Figure 4 - SEPP 53 Ku-ring-gai Reference Plans – Site 1 Building Envelope Control Drawings

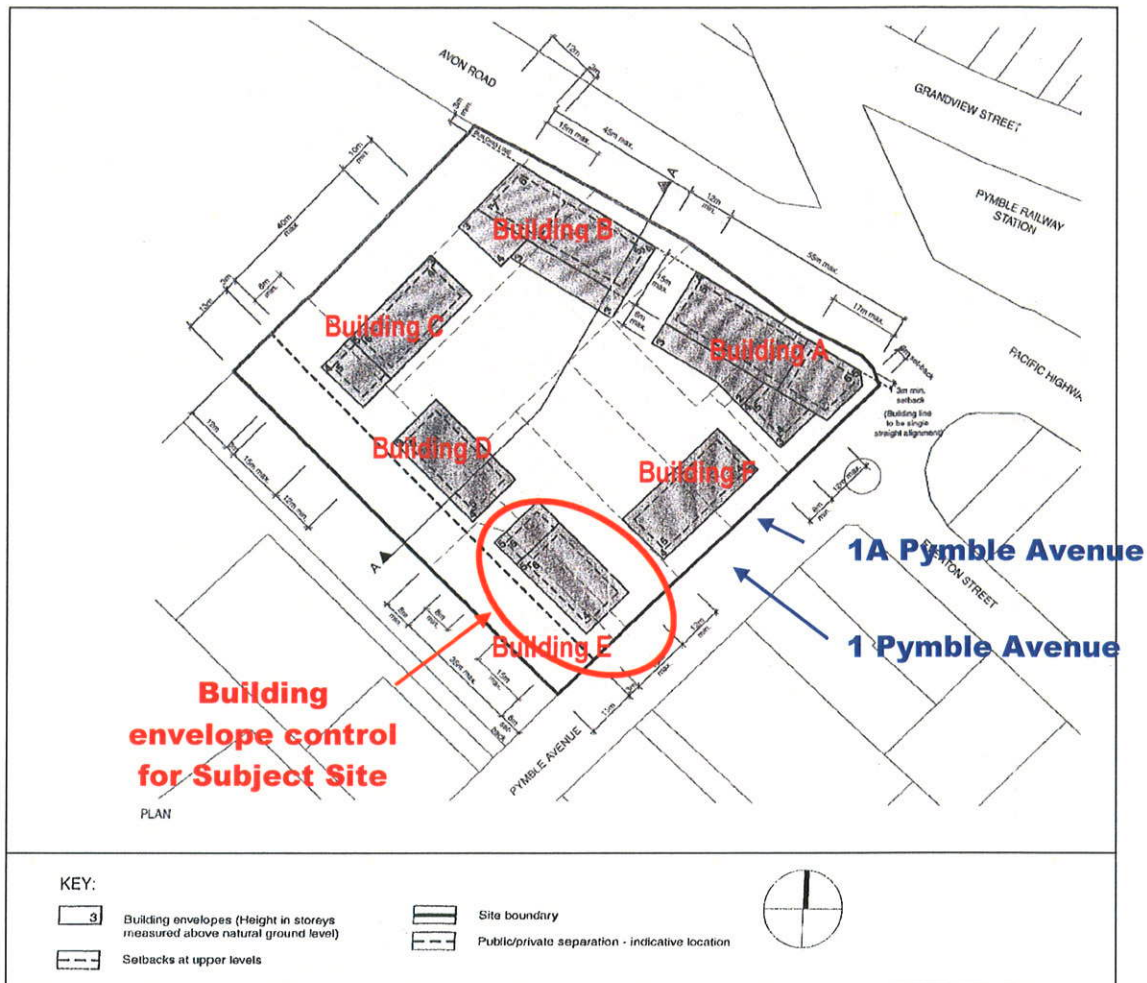
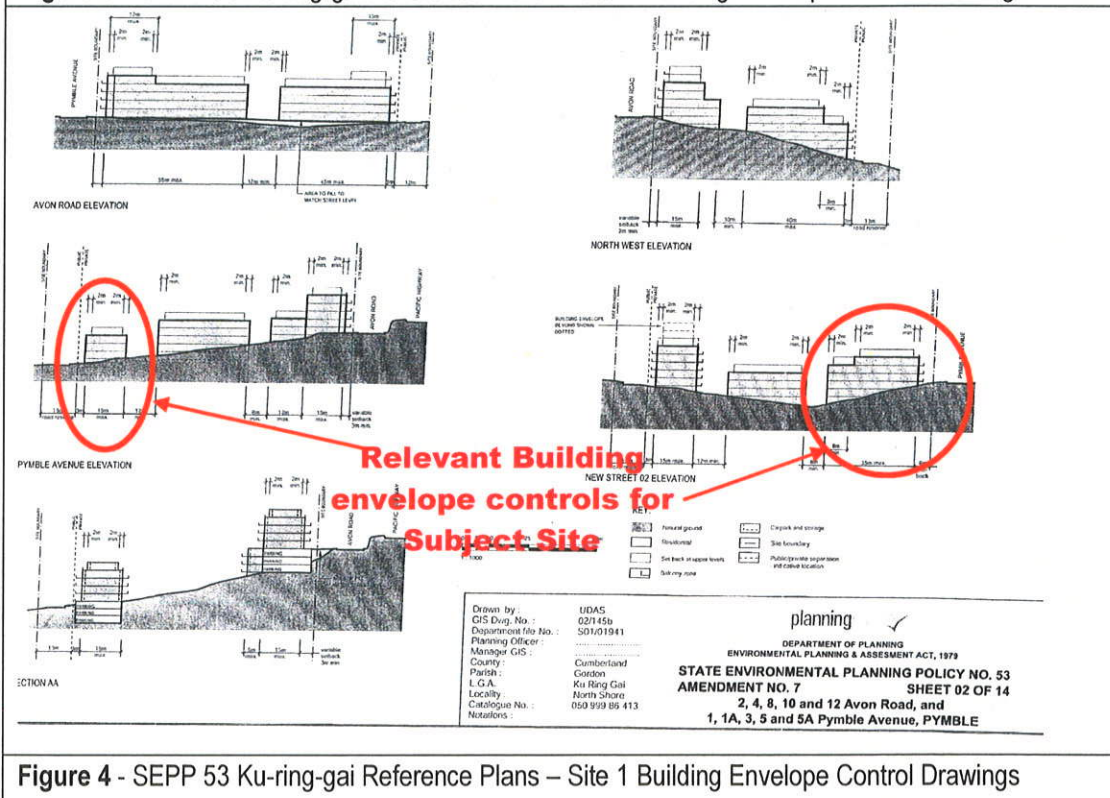
The non-compliances in regards to building height, envelope, setback and dimension (length & width) are considered to be generally minor variations to the controls and do not have an adverse impact on the overall bulk and scale of the proposal, nor upon any adjacent or nearby residential properties.

The variations to the height/envelope controls are partly a function of the steeply sloping site which features falls in the order of 7 metres from front to rear and approximately 3.5 metres from side boundary to side boundary.

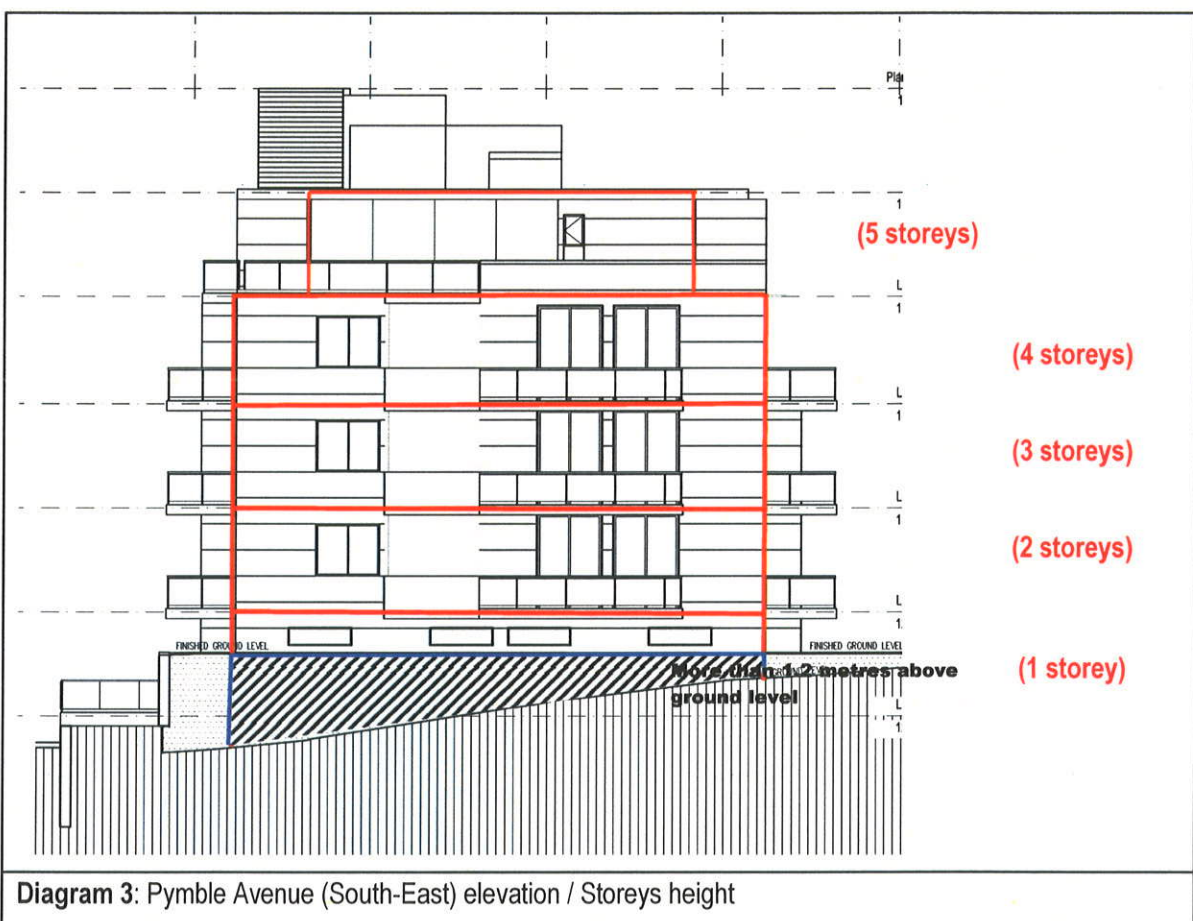
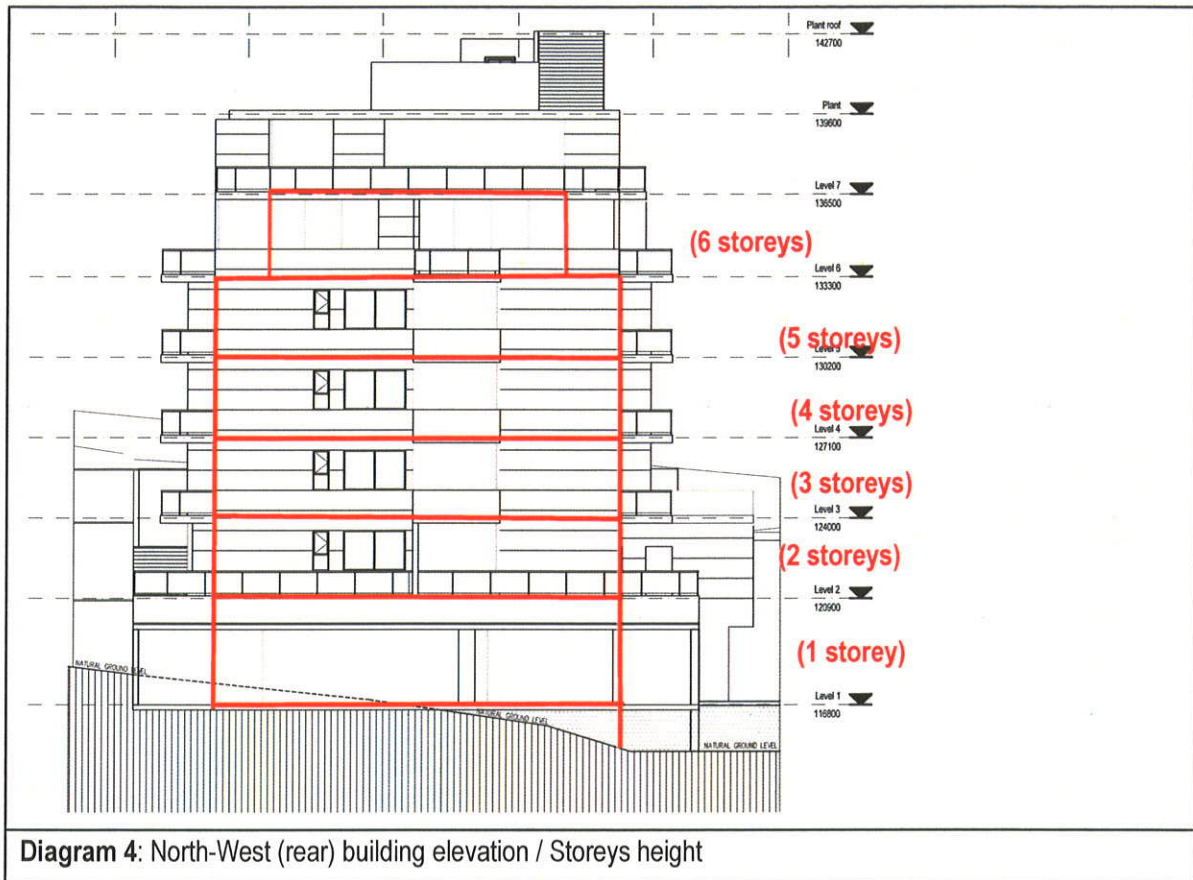
The only non - compliance occurs at the Pymble Avenue frontage in respect of Level 3, Units 315 and 316 where the ceilings project more than 1.2 metres above ground level at the southern and eastern corners (by 2.4 metres and 800mm respectively), resulting in a 1 storey non - compliance (see Diagram 3 and 5 below).

The non-compliance at the eastern corner is "carried around" onto the north-eastern elevation fronting the side boundary with the adjacent residential property, No. 1 Pymble Avenue (refer Diagram 5).

The remainder of the north-eastern (side) elevation complies with the height envelope control (refer Diagram 5).

In respect of the Pymble Street elevation, compliance could be achieved by requiring a step in the building across its short dimension; however, such a requirement would have a serious effect on layout, design and dwelling yields. Alternatively, the building could be lowered further into the ground, however, the common access driveway and basement levels between Building's D and E would not match.
